TECHNICAL BULLETIN

RUPES HLR15

Ibrid Random Orbital Polisher

Technical updates on motor body and rotor bearing

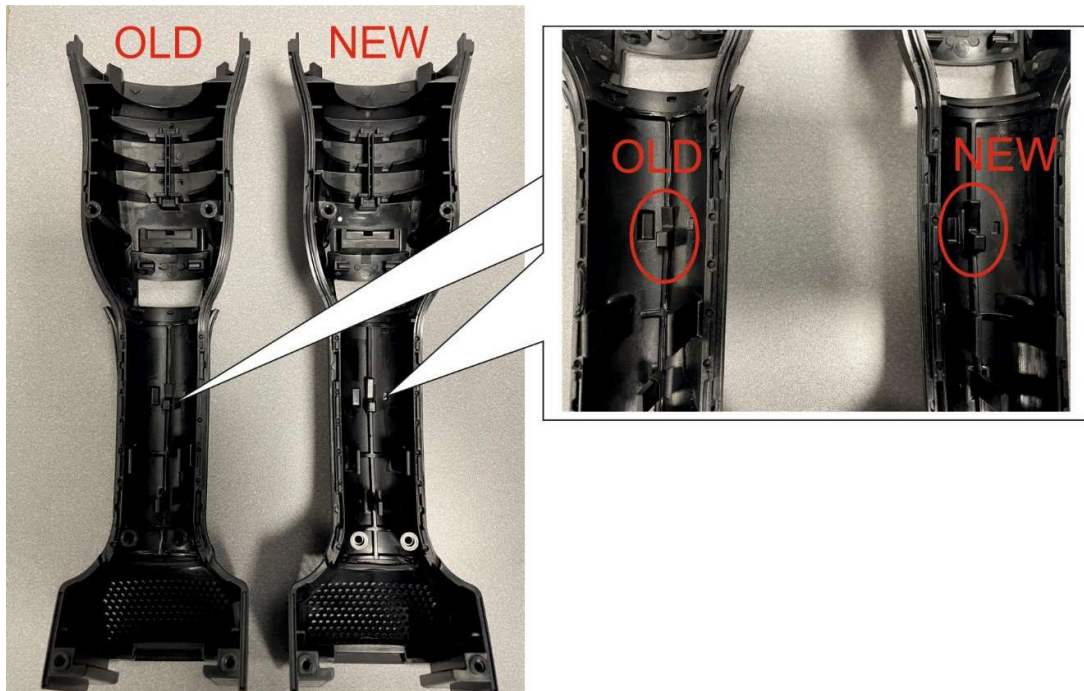
The difference between the old and new version of the lower motor body 31.396/C:

The difference between the old and new version of the upper motor body 311.396/C:

- Replace of motor body both for the lower part 31.396/C and the upper part 311.396/C
- New rotor bearing with o-ring (cod 9.579)
- Remove rubber bearing cover (cod 268.400)
